HISTORIC AND DESIGN REVIEW COMMISSION August 04, 2021

HDRC CASE NO: 2021-365
ADDRESS: 822 N PINE ST

DISTRICT: Dignowity Hill Historic District
APPLICANT: lance Lubke/ALL LIVING TRUST
OWNER: lance Lubke/ALL LIVING TRUST
TYPE OF WORK: Installation of 1x6 porch decking

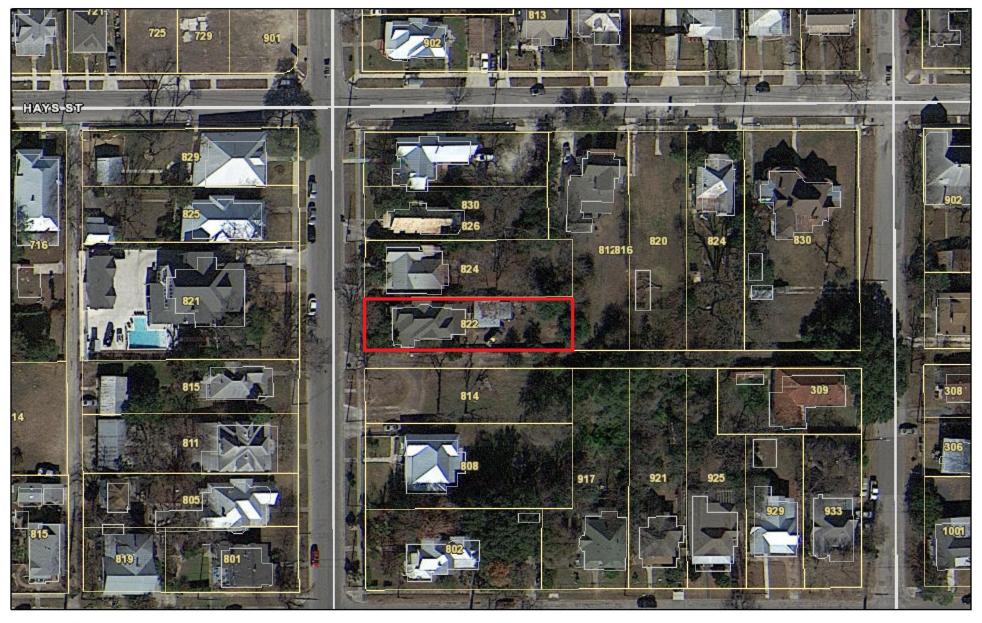
- c. DECKING REPLACEMENT The applicant has proposed to replace the existing, non-original, 1x12 porch decking boards with 1x6 porch decking boards. Per the Guidelines for Exterior Maintenance and Alterations, replace in-kind porches, balconies, porte-cocheres, and related elements, such as ceilings, floors, and columns, when such features are deteriorated beyond repair. When in-kind replacement is not feasible, the design should be compatible in scale, massing, and detail while materials should match in color, texture, dimensions, and finish. Staff finds the replacement of non-original porch decking to be appropriate; however, staff finds that 1x3 tongue and grove porch decking should be installed, perpendicular to the front façade of the historic structure.

i. That the applicant install porch decking that features a 1x3, tongue and groove profile and that all decking is installed perpendicular to the front façade.
